# 1963 - 1964 Corvette: Service Bulletin: 3-Speed Transmission Problems

**Source:** Chevrolet Technical Service Bulletin

**Bulletin No:** TSB #1008 DR #676

**Date:** July 16, 1964

FIGURE 2 - MAST JACKET ASSEMBLY

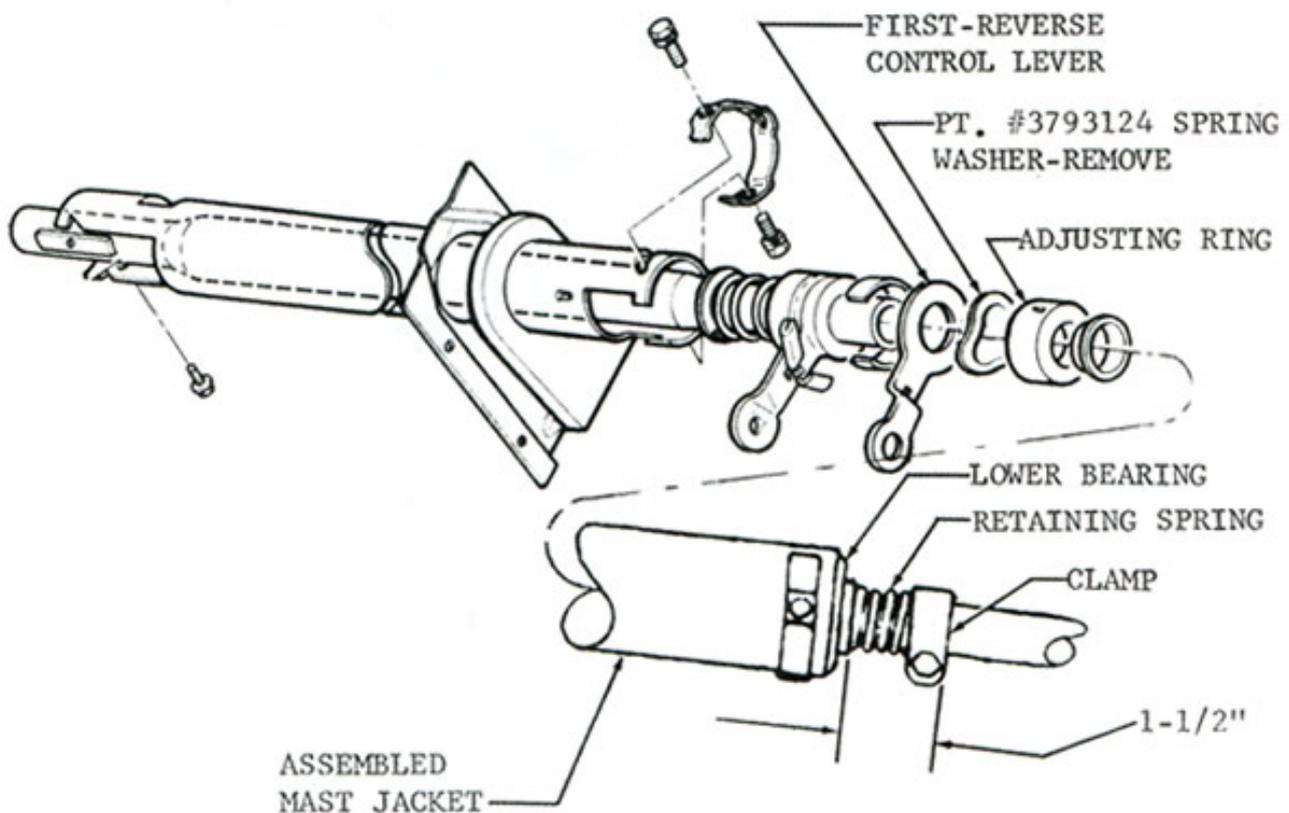
To provide a more positive shift on truck models, Part No. 3793124, transmission control 1st and reverse lever spring washer is being omitted in production and should be removed from units in service. The procedure to remove this spring washer and to readjust lever clearance is as follows:

1. Refer to Figure 2 for parts identification. Place shift lever in neutral; remove access cover from fender skirt.

2. Remove cap screws retaining adjusting ring to mast jacket.
3. Loosen steering shaft lower bearing retaining spring clamp.
4. Slide adjusting ring downward along steering shaft until Part No. 3793124, spring washer, is exposed. Cut and remove spring washer from steering shaft.
5. Apply lubriplate to thrust surfaces of control levers, relay lever and adjusting ring.
6. Position adjusting ring in mast jacket; align holes in ring with slots in mast jacket and install cap screws, but do not tighten.
7. Rotate adjusting ring upward until clearance of .005" exists between first-reverse control lever and ring as shown in Figure 3. Tighten cap screws.

8. Force lower bearing retaining spring clamp upward against spring tension until a dimension of 1-1/2" exists between lower bearing and clamp as shown in Figure 2. Tighten clamp bolt.
9. With transmission side cover selector levers in neutral position, adjust selector rod lengths per instructions in the appropriate shop manual to provide proper neutral cross-over. Replace access cover when adjustments are completed.

FIGURE 4 - INSTALLATION OF THRUST WASHERS IN CHEVY VAN

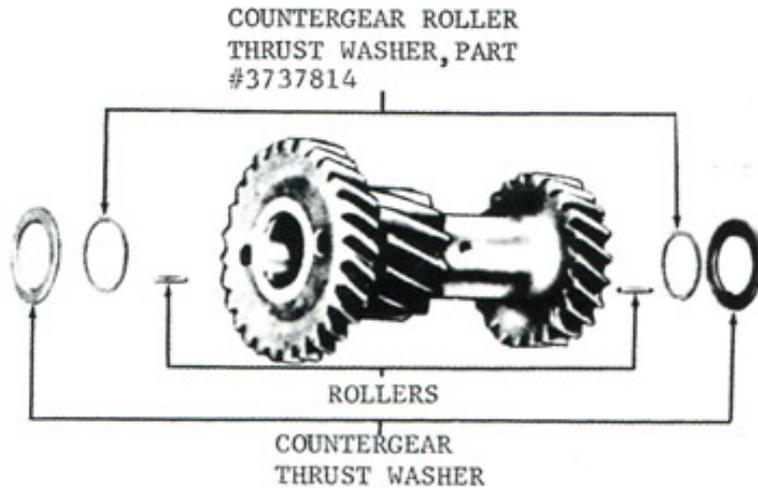
On Chevy Van models with three-speed transmissions, a small steel thrust washer is used between the countergear thrust washer and the countergear roller bearings at each end of the countergear. Since the 1964 Chevy Van Shop Manual is supplemented to the 1963 Truck Shop Manual in this area, reference to this part is omitted in error.

Figure 4 illustrates installed location of this thrust washer in Chevy Van transmissions.

FIGURE 5 - INSTALLATION OF MAGNETIC CHIP COLLECTOR

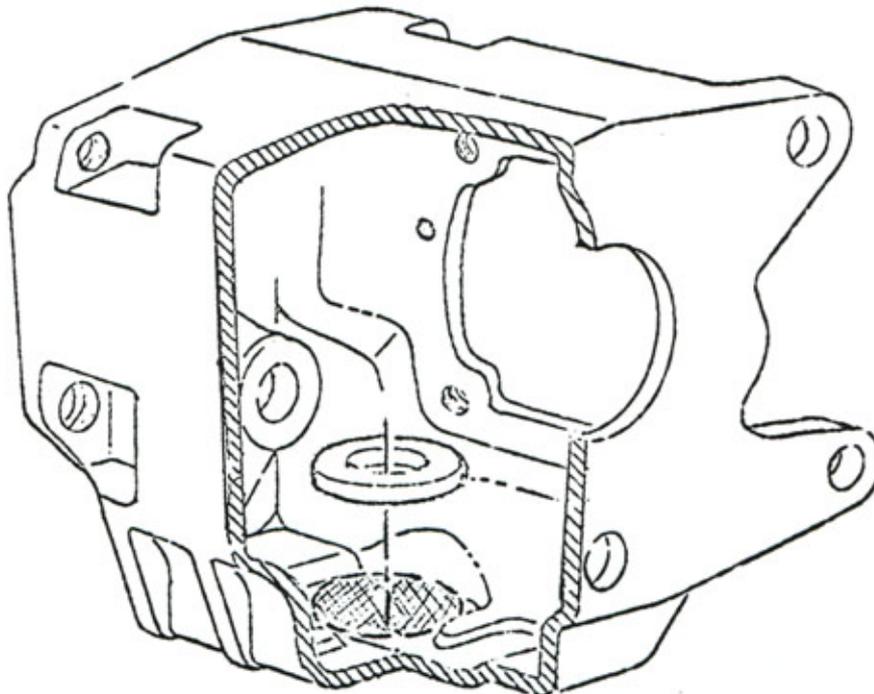
To reduce bearing noise and increase bearing durability, two changes have been released for production. First is the installation of a magnetic chip collector which went into effect on June 5, 1964. Second is the use of a new clutch gear and mainshaft bearing that incorporates a slinger ring on the inner race. This change went into effect on transmissions for use on 327 cu. in. engines on June 11, 1964, and is estimated to go into effect the week of June 22, 1964, on remaining transmissions.

Service Kit #3869240 has been released for field installation of the chip collector on 1963 and 1964 3-speed transmissions built prior to the above dates. The kit includes the magnet, cement, and instruction sheet. It also contains a 3/8 inch high pedal bumper for increasing clutch release on all except Chevy Van (Reference - Gear Clash - First and Reverse Shift). It is recommended that whenever a 1963 or 1964 3-speed transmission is disassembled for any reason, that the magnet be installed using the following procedure.

3. Wipe magnet and area in case where magnet is to be installed with Acetone or Toluol (available at most drugstores). Area where magnet is to be installed must be clean, dry and free from oil and grease film. When Acetone or Toluol is applied, be sure to use in ample quantity to neutralize grease and oil which may be in pores of casting surface. Do not touch cleaned area with hands.

4. Using cement supplied in kit, apply about a 1/16 inch thick film over entire bottom surface of magnet and immediately place in case as shown in sketch. Press straight down - do not twist while pressing in position. Note: If cement from tube appears to be thick, discard thick or hardened chunks and use cement from middle or bottom of tube.

5. To cure cement, place a trouble light with a 100 watt lamp inside of case as close to magnet as possible, and allow to stand for a minimum of 30 minutes. Use care not to touch magnet or knock it out of position. A heat lamp, if available, may be used in place of 100 watt lamp.
